VIRGINIA ELECTRIC AND POWER COMPANY
SURRY POWER STATION UNITS 1 AND 2
PROPOSED LICENSE AMENDMENT REQUEST
CONTAINMENT SUMP INSPECTION SURVEILLANCE
RESPONSE TO NRC REQUEST FOR ADDITIONAL INFORMATION

Response to NRC Request for Additional Information

Response to NRC Request for Additional Information
Containment Sump Inspection Surveillance Requirements

Surry Power Station Units 1 and 2

Sketch 1

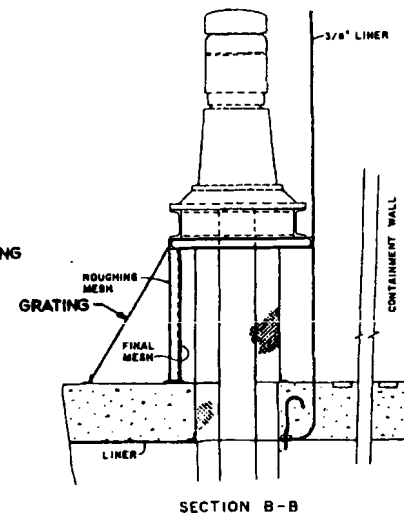
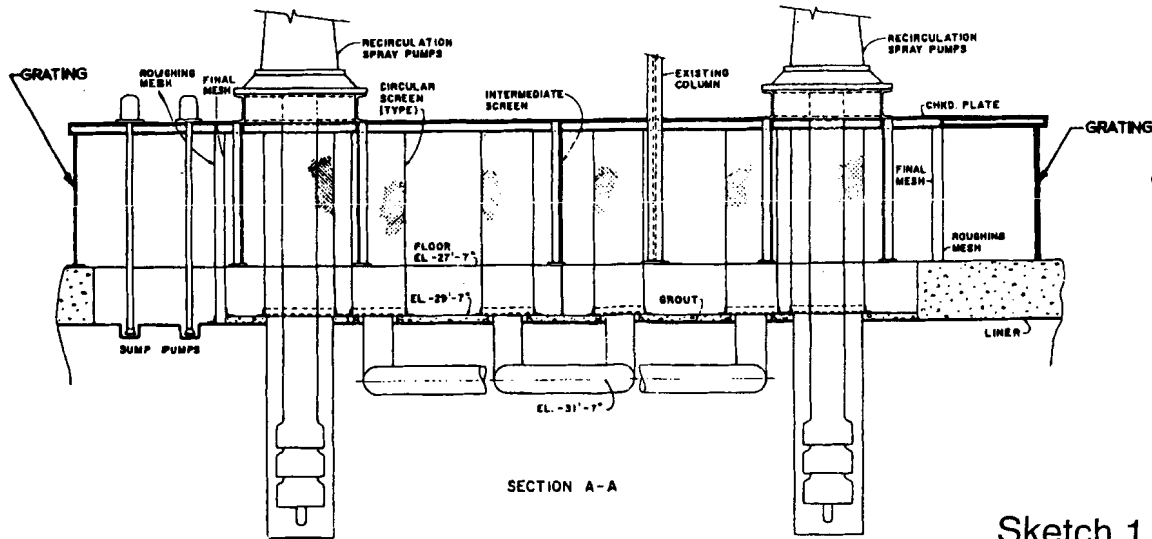
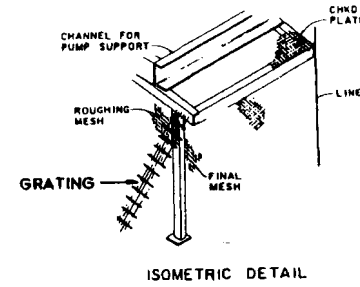
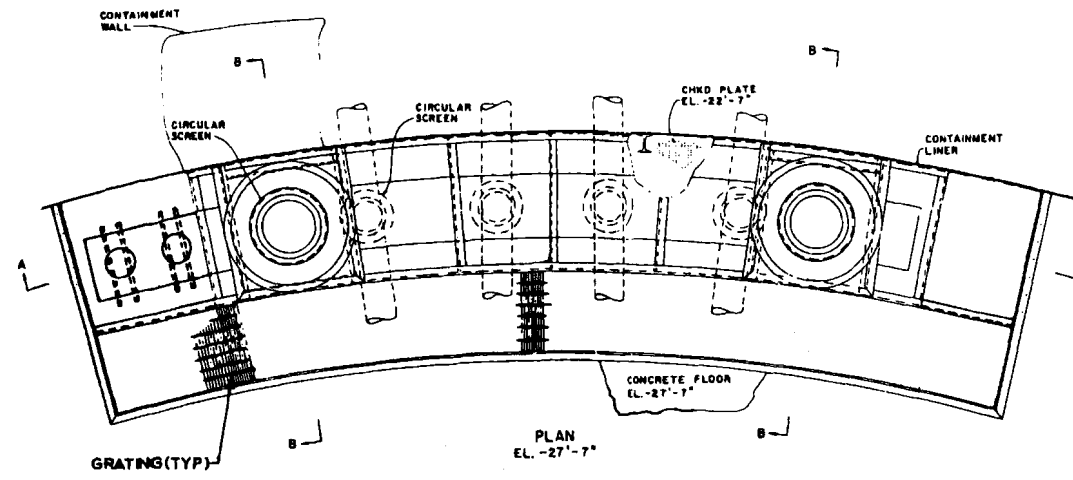
- 1. Provide a simple sketch of the layout showing the arrangement for the existing and modified containment sump designs. What is the total strainer area of the modified sump strainer design compared with the total area of the existing sump strainer design?*

The configuration of the Surry containment sump strainer is shown in Sketch 1. The sketch reflects the existing Surry Unit 1 strainer arrangement. The Unit 2 strainer configuration (prior to the implementation of the partial strainer replacement modification performed during the fall 2006 refueling outage) was similar to Unit 1. Sketch 2 shows the current configuration of the containment sump strainer pump suction header that was installed in Surry Unit 2 during the fall 2006 refueling outage. Sketch 3 shows one of the four installed modules. Sketch 4 shows the final configuration of the containment sump strainers that will be installed in Surry Units 1 and 2. (Note: Surry Unit 1 shown.)
